SUBJECT: ISSUANCE OF AMENDMENTS FOR CALVERT CLIFFS NUCLEAR POWER PLANT,
UNIT NO. 1 (TAC NO. M84610) AND UNIT NO. 2 (TAC NO. M84611)

The amendments revise the Site Boundary Map and the Low Population Zone Map.

AMENDMENT NO. 190 TO FACILITY OPERATING LICENSE NO. DPR-53-CALVERT CLIFFS
UNIT 1

AMENDMENT NO. 167 TO FACILITY OPERATING LICENSE NO. DPR-69-CALVERT CLIFFS
UNIT 2

FIGURE 5.1-2
LOW POPULATION ZONE

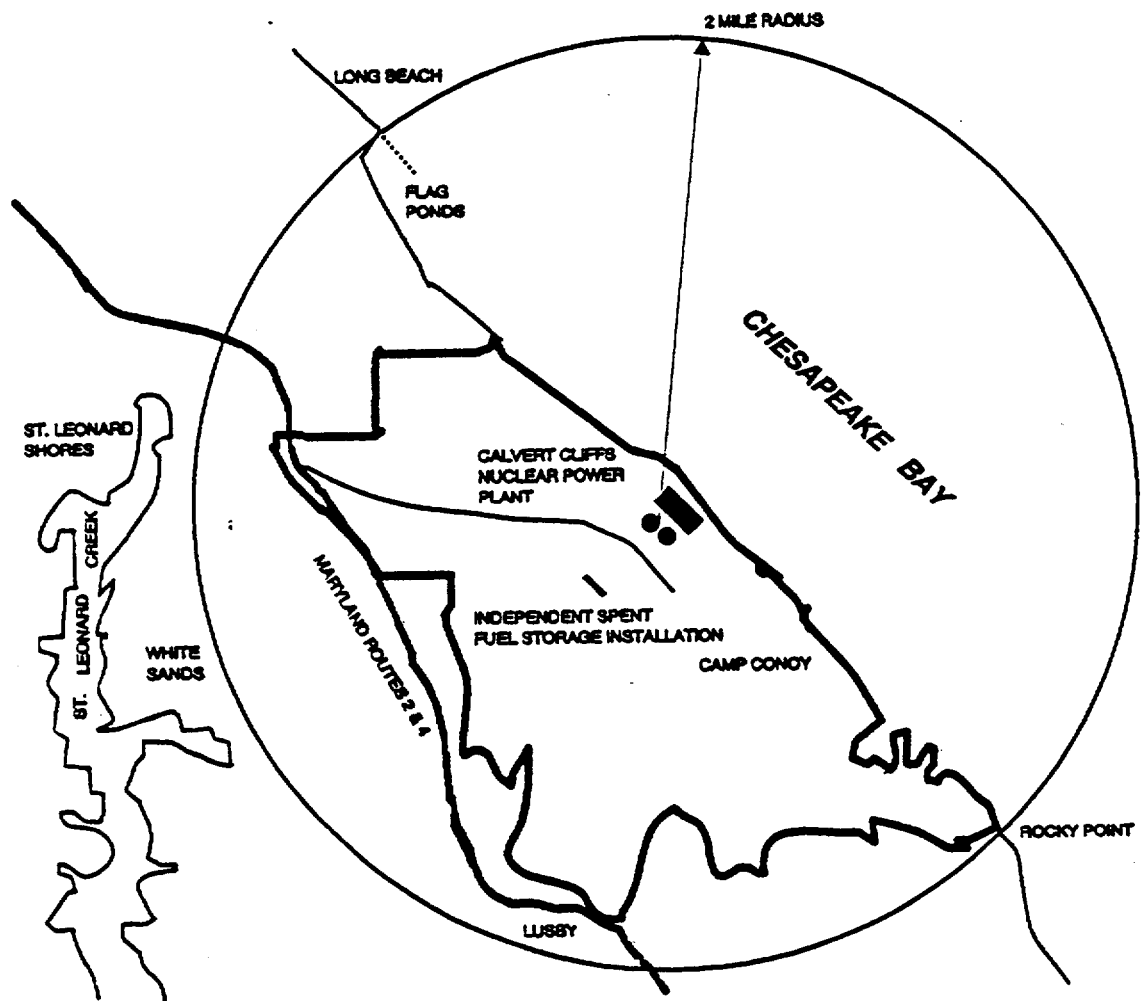
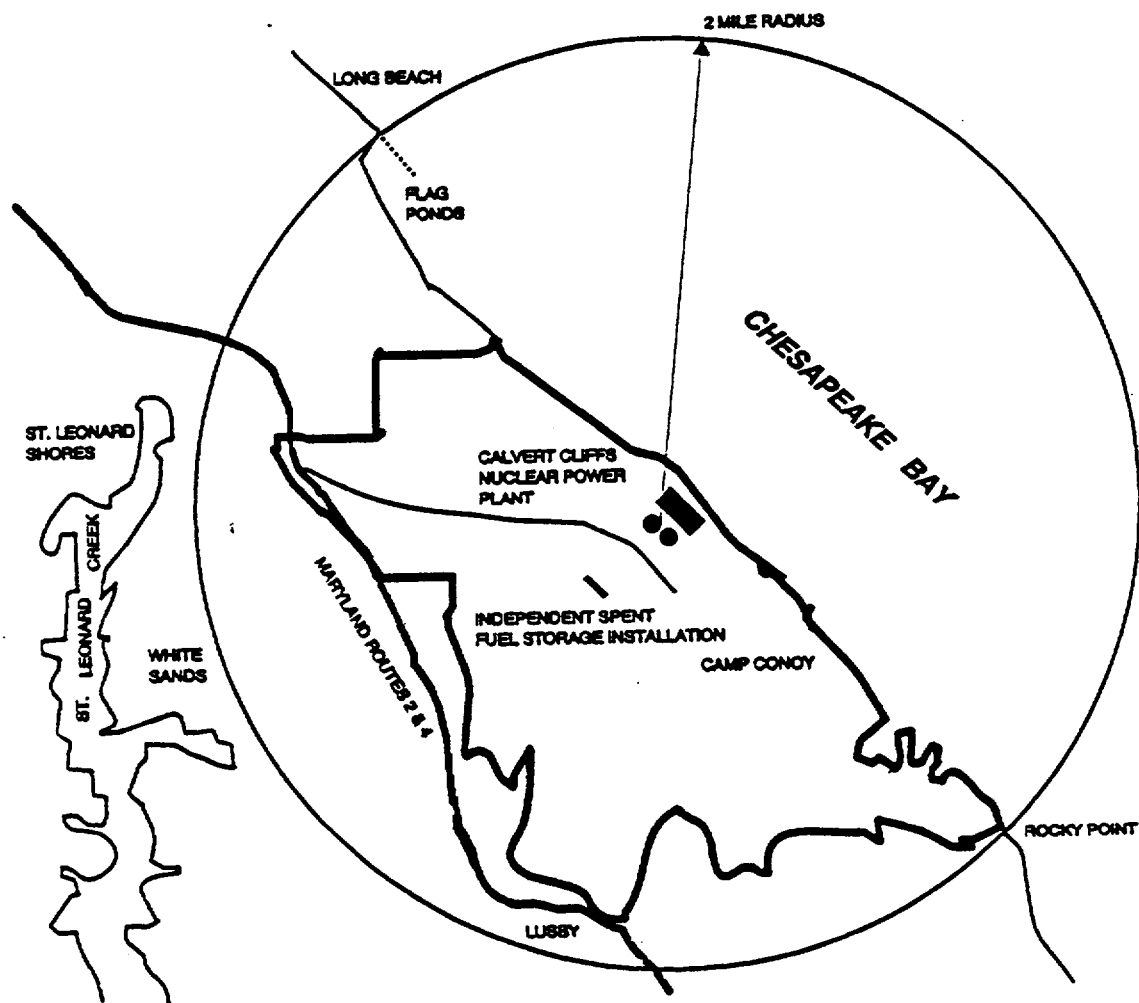
TS Section 1.0, Definitions, states "The Site Boundary shall be that line beyond which the land is neither owned, nor leased, nor otherwise controlled by the licensee." Six parcels of land were purchased by BG&E which increased the size of the plant site. At the time of the purchases, the licensee did not update the Site Boundary Map and the Low Population Zone Map to reflect this land addition. During a recent quality assurance audit of the TS the auditors noticed the discrepancy between the actual site property lines and the site property lines shown on TS Figure 5.1-1, Site Boundary Map, and Figure 5.1-2, Low Population Zone Map. By these requested amendments, the licensee proposes to correct this discrepancy.

The staff has reviewed the amendments and concludes that the changes to TS Figures 5.1-1 and 5.1-2 accurately reflect the site boundary and are, therefore, acceptable.
